Addendum #2

Date: December 17, 2025

Subject: Addendum #2
H&P Project # 2025087
Seneca Park Phase 1 Water & Sewer
Campbell County, VA

HURT&PROFFITT	
SHEET NO.	REV.
C-102	----

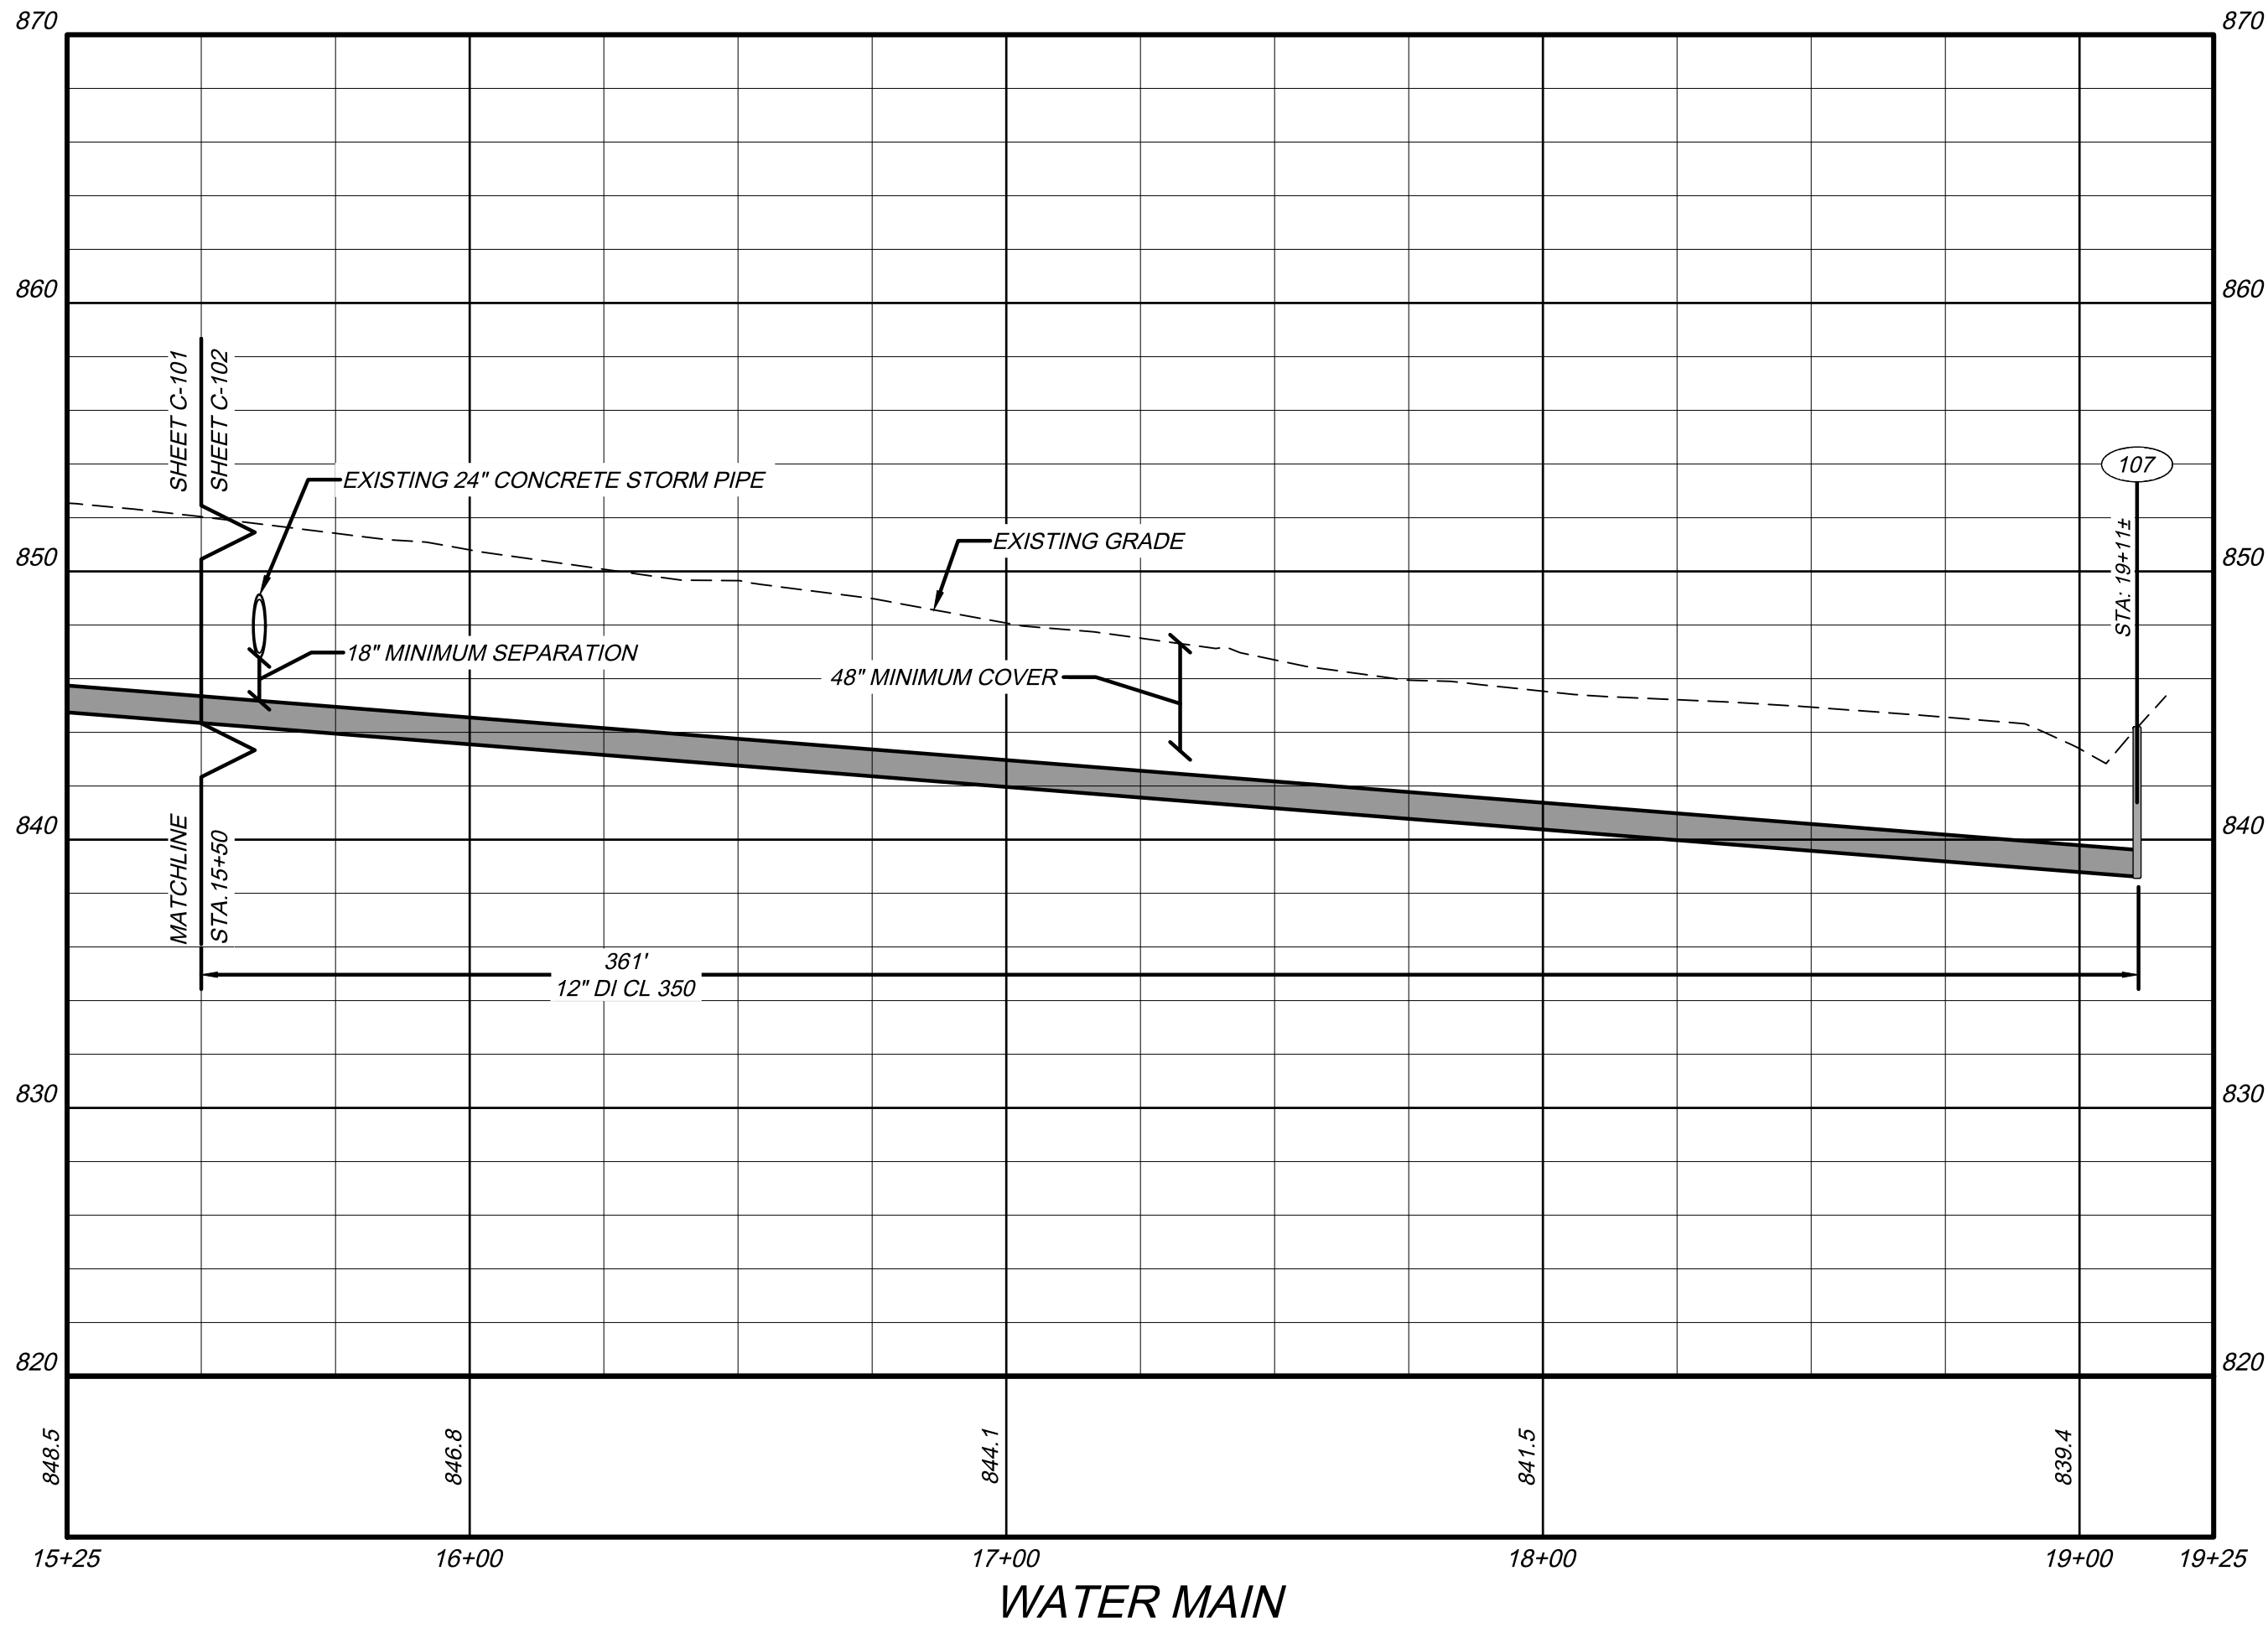
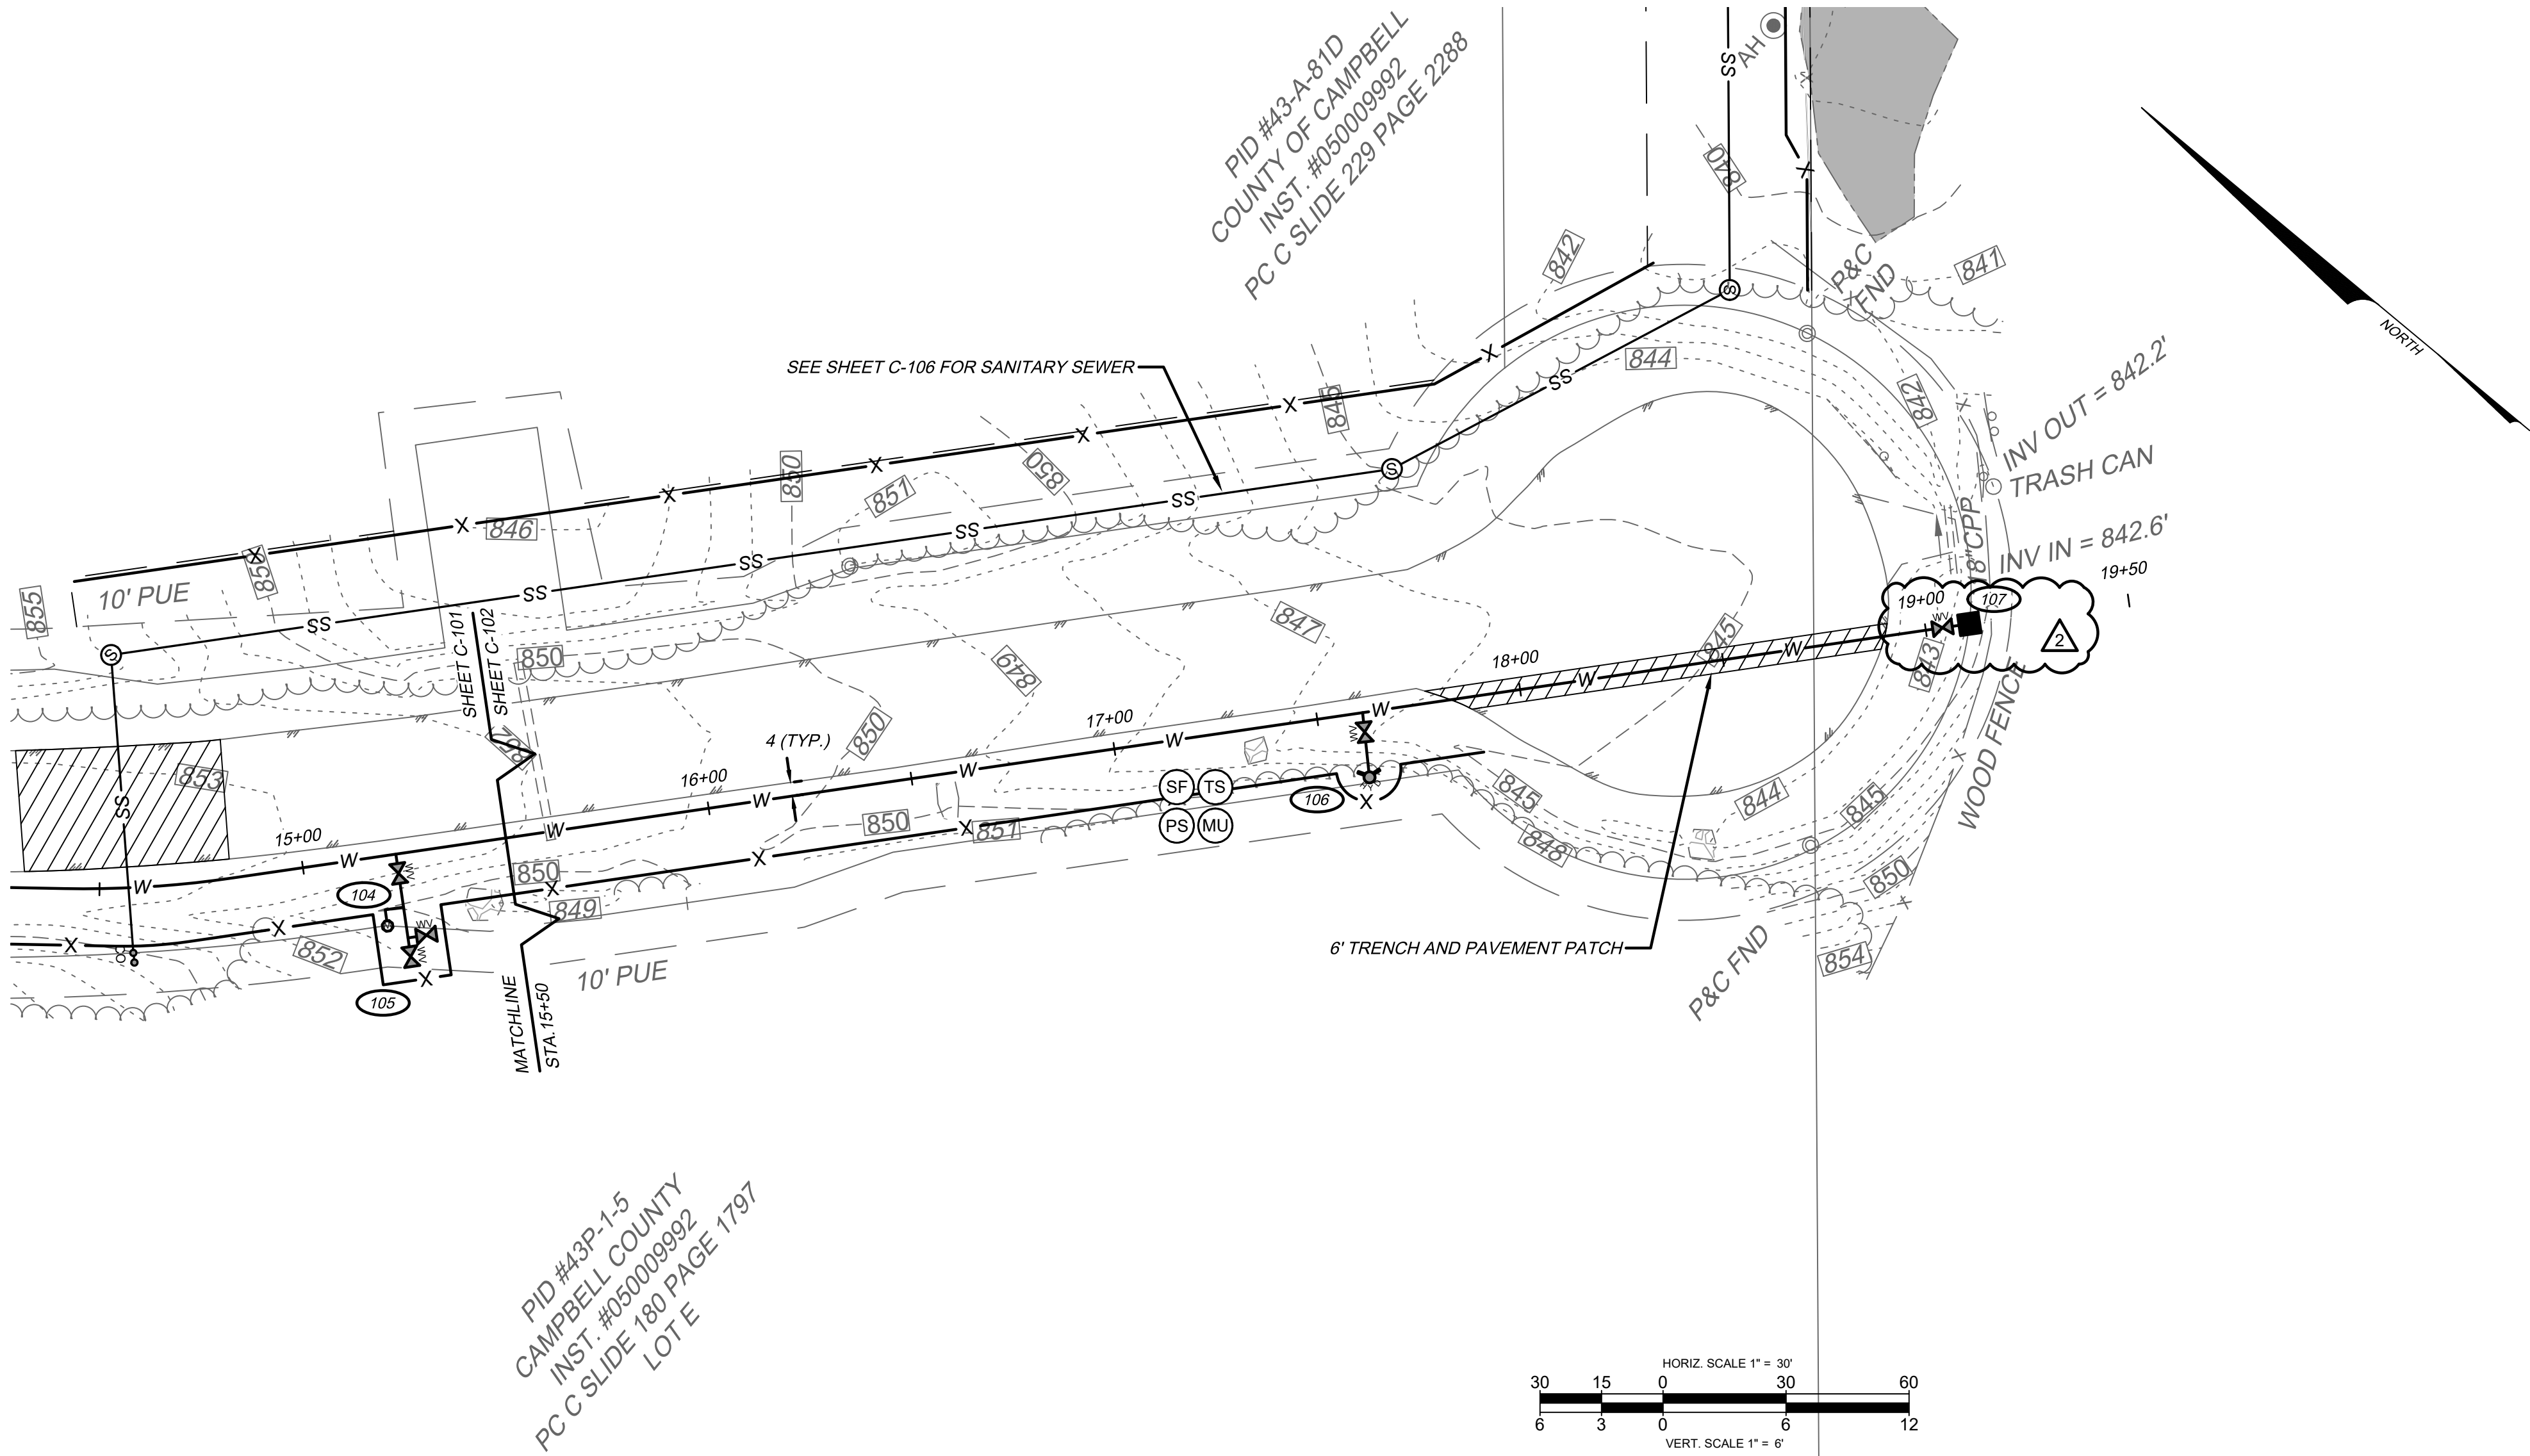
Item Five: Water Line Structure

Water Line Structure 107 description has been updated on the plan sheet to be a 12" gate valve and EOL flushing hydrant.

4. At the end of the 12" water line the plans show a 6" gate valve. Is this correct?

Response: Structure 107 will be changed to an EOL blow-off. Plan sheet and bid form will be updated and sent out with Addendum.

WATERLINE STRUCTURE SCHEDULE	
STA: 17+61±	REQ'D:
106	1 - FIRE HYDRANT ASSEMBLY (CCUSA W-210)
	16 LF OF 6" DI WATER MAIN
	1 - 12" x 6" DI TEE
STA: 19+11±	REQ'D:
107	1 - 12" GATE VALVE & BOX
	1 - END OF MAIN LINE (W/ MAIN LINE VALVE) FLUSHING HYDRANT (CCUSA W-420)
